**Re: Response to December 6, 2018 Planning Board Meeting Minutes
Townhomes at Dryden project**

**Re: Response to December 17, 2018 Full EAF Review by T.G. Miller, P.C
Townhomes at Dryden project**

SITE IMPROVEMENT PLAN
TOWNHOMES AT DRYDEN
TRINITAS VENTURES
 366 DRYDEN ROAD, ITHACA, NY 14850 TOWN OF VARINA, TOMPKINS COUNTY, NY

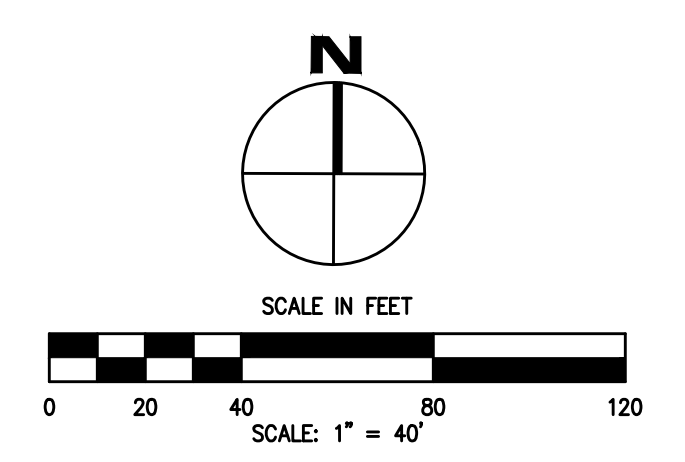
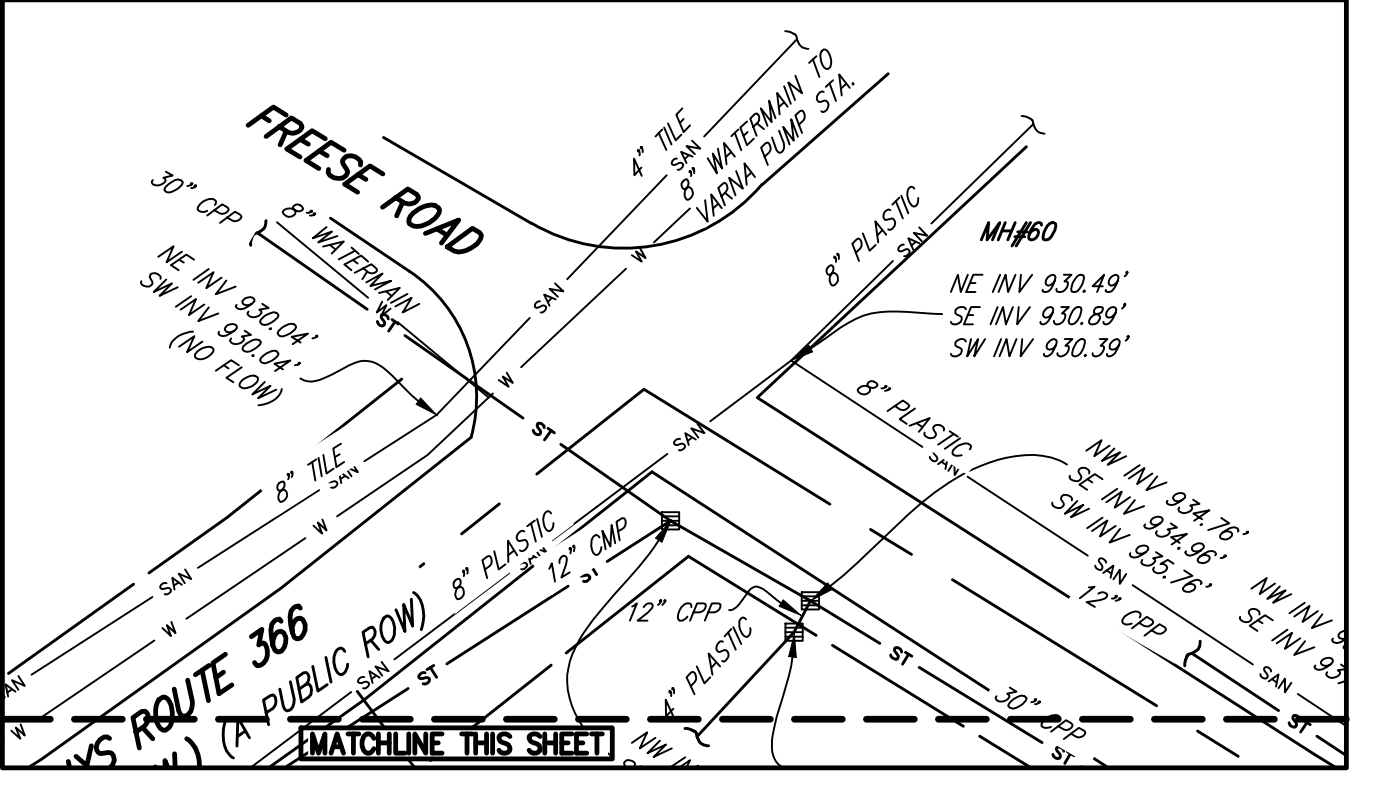
- Part iii – Water service extension within Rte. 366 R.O.W. will require a service agreement and dedication of infrastructure to the Town. Checkbox should be marked “yes”.
- Show location of existing utilities along NYS Rte. 366 per Town record maps previously provided.
- Site Utility Plan L3.0 shows a proposed waterline parallel to Mt. Pleasant. This connection should be removed leaving one connection from NYS Rte. 366 at the northern site entrance.

Anticipated domestic water usage demands for the project have been revised to include a range as requested. Parts ii and iii have been revised also as requested. The site plan maps have been updated per the plans sent to our office. Site Utility Plan L3.0 has been revised to remove the additional connection along Mt. Pleasant. It is understood the Town’s engineer will evaluate the water model and determine if this connection is needed.
